16 December 2022

Reference: P190302

**RE: Oldcourt Road, Firhouse, Dublin24 – Request for Additional Information
Pertaining to Planning Reg. Ref. SD22A/0356**

Typical Rain Garden Details

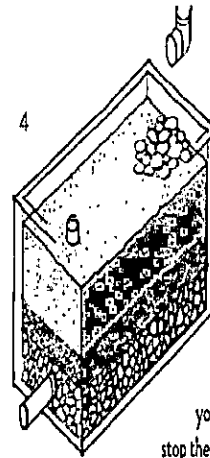
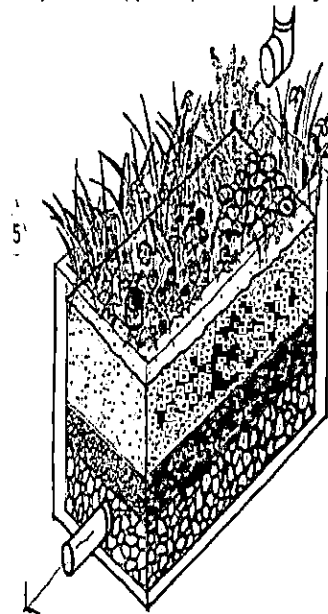
(a) A report is requested showing surface water attenuation calculations for proposed development. Clarify what capacity there is in all attenuation systems being used. If an attenuation system is already being used by a different development submit

design calculation of all development using such a surface water system. Surface water should be attenuation by means of SuDS (Sustainable Drainage Systems) first. Only where SuDS does not provide sufficient surface water attenuation and only in exceptional circumstances shall underground attenuation systems be considered of an arched type system.

Examples of SuDS and this is not an exhaustive list include: - Green roofs or blue roofs

- Permeable Paving - Grasscrete
- Swales
- Rain Gardens , Planter boxes Water Services Planning Report - Filter drains
- Other such SuDS

Examples of SuDS can be found in South Dublin County Council Website at: [sdcc-sustainable-drainage-explanatory-design-and-evaluation-guide.pdf](#) Submit a drawing in plan and cross-sectional view showing design details of all proposed SuDS systems.

(b) A report and drawing is requested showing a flow route analyses of proposed site. A proposed SuDS system should take account of existing flow route of the site.

Examine how surface water flows can be managed at or above ground level. Surface water discharge should be to green field run off rates or 2 litres/second/hectare whichever is greater.

Further to the above, we would consider that this slight increase in impermeable area is fairly negligible, however, if it is considered to be an issue by SDCC, we would propose that a type of rain garden, as illustrated in Appendix A, be implemented into the rear gardens of the additional 7 No. units, as indicated on the aforementioned drawing. These proposed rain gardens would accommodate a total run-off equating to circa 294m², based on half of the roof area of the unit draining to the rear and being collected by the rain garden. This measure would then counteract the slightly additional impervious area, as illustrated above.

1. Once you have chosen your location, your box, and the drain you are reconnecting to, you'll need to cut a hole in the empty box for your outflow pipe to come out of. Cut off your downpipe above the top of your box, and add a new downpipe shoe or decorative spout to take the water into your box.

Starting from the bottom of the empty box, install a perforated (holey) pipe along the bottom, making sure that there is a slight slope along the pipe. You can use a bit of gravel at one end to help with this. Connect this outlet pipe back to the drain. You should connect a high level overflow to this pipe, which will take rainwater if your box becomes completely full.

Once the plumbing is completed and has been checked carefully, you can begin to add the layers of gravel and soils. It is best to do this with the box where you'd like it to be, as it will be too heavy to move once full.

2. Add roughly 200-250mm depth of larger gravel. Make sure you give the gravel a wash so that no dirt could wash out and block the drain. Then add a geo-textile layer on top of this. This layer is to stop the two different sized gravels mixing up, but needs to be able to let water through.
3. Next add about 100mm depth of finer gravel, again after giving it a good wash, followed by another geotextile layer. This layer is to stop the layer above and below mixing together, but needs to be able to let water through.

4. On top of this add a minimum 350mm of material that the plants are going to be growing in, so that they will have enough room for their roots. As a guide, this material can be made up of 55% sand, 30% existing soil and 15% compost. It should be free draining so that your plants do not end up soggy and waterlogged. If you have clay soil avoid using this.

Below where the new gutter spout is located, you should add some decorative stones, which will stop the soil from being washed away as the rainwater splashes out. Also add a small grate or perforated cap to the top of your overflow pipe, to stop debris from washing down.

5. Finally, plant up your box with suitable plants. These could include yellow flag iris, ragged robin, cuckoo flower, cranesbill, geraniums, rosemary and thyme. You'll find more suggestions on our website. Happy raingardening!
